Planning Application Ref: AL/92/21/T

Location: 17 Ivy Close, Westergate, Aldingbourne, PO20 3RF

Description of works: Oak (T1) - crown reduction and crown lift. It is recommended to complete a 30% crown reduction (2.5-3.5m) and crown lift to keep the branches off the footpath and away from the road (5m). This will leave a span of 14-16m and height of 18-20m

Figure 2 Positions of final cuts

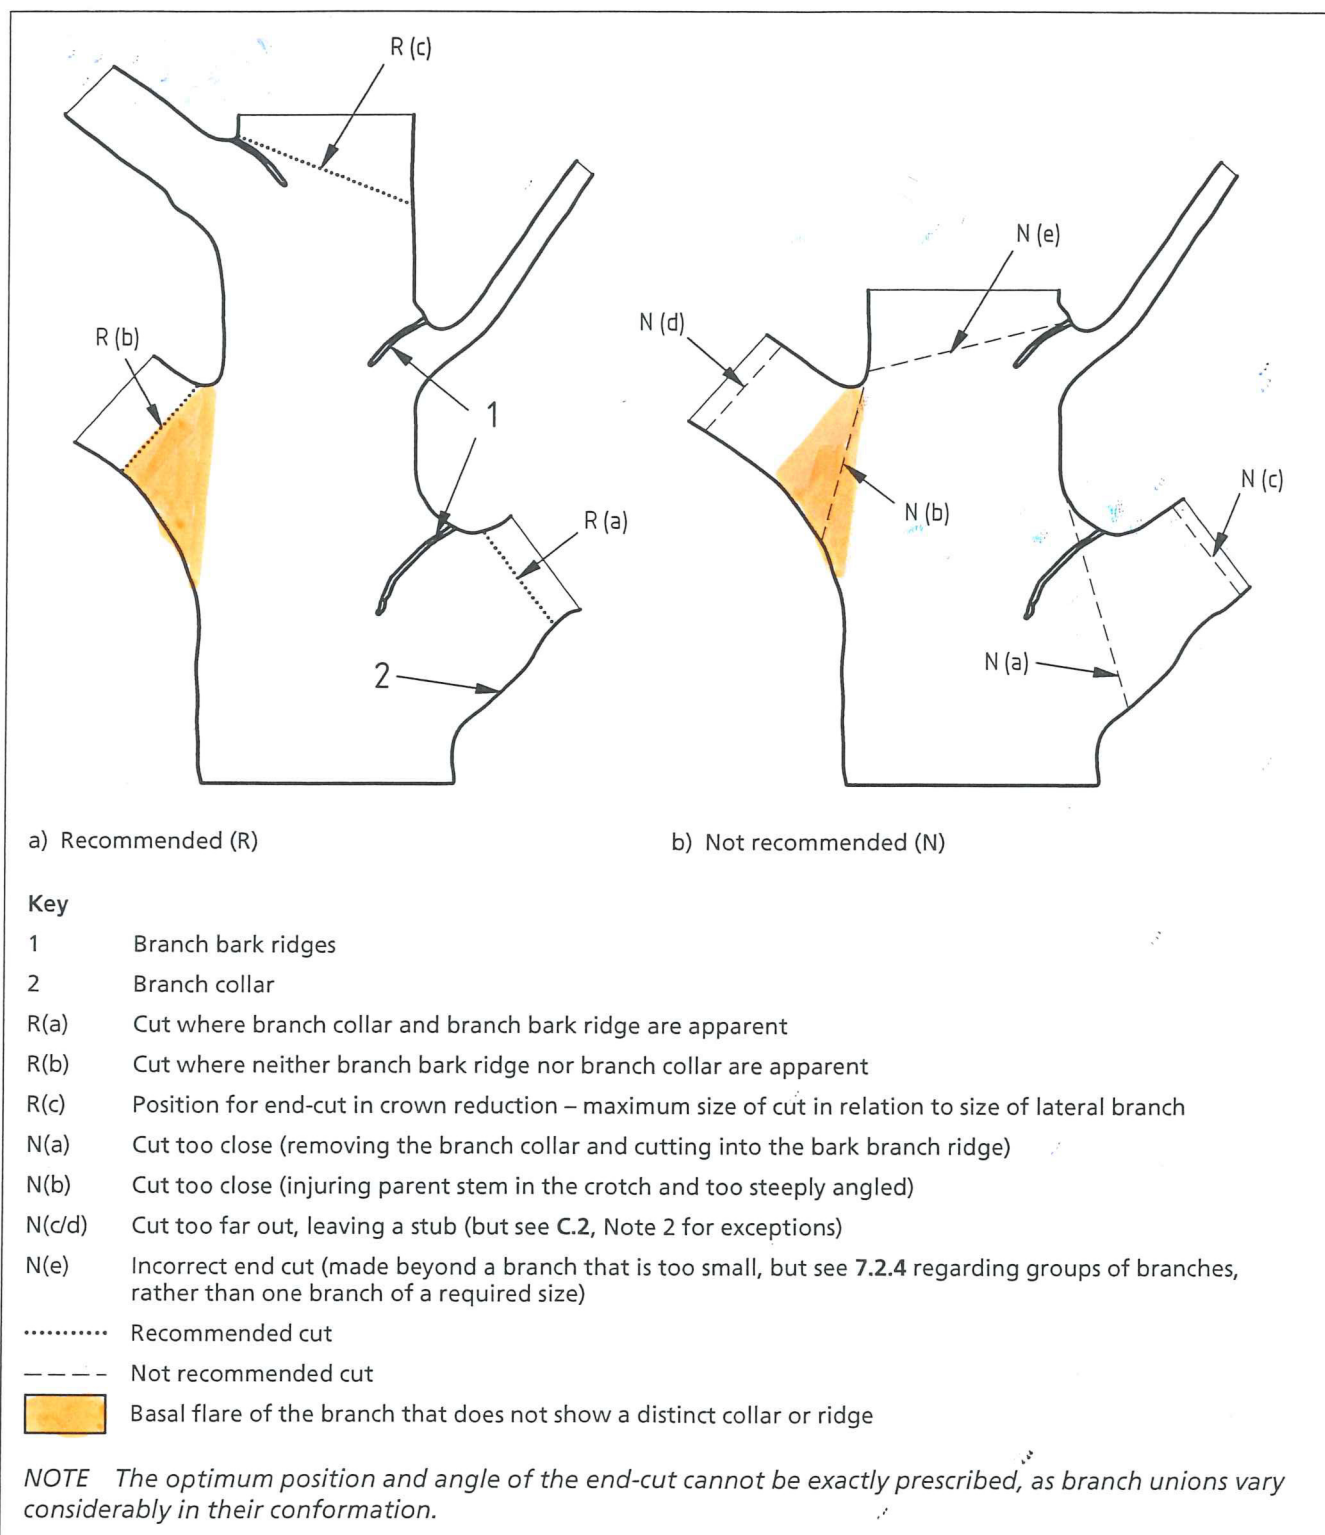
Part a) Where whole branches are to be removed and final cuts made close to the trunk or branch union they are to be made as shown in Figure 2 of BS3998:2010
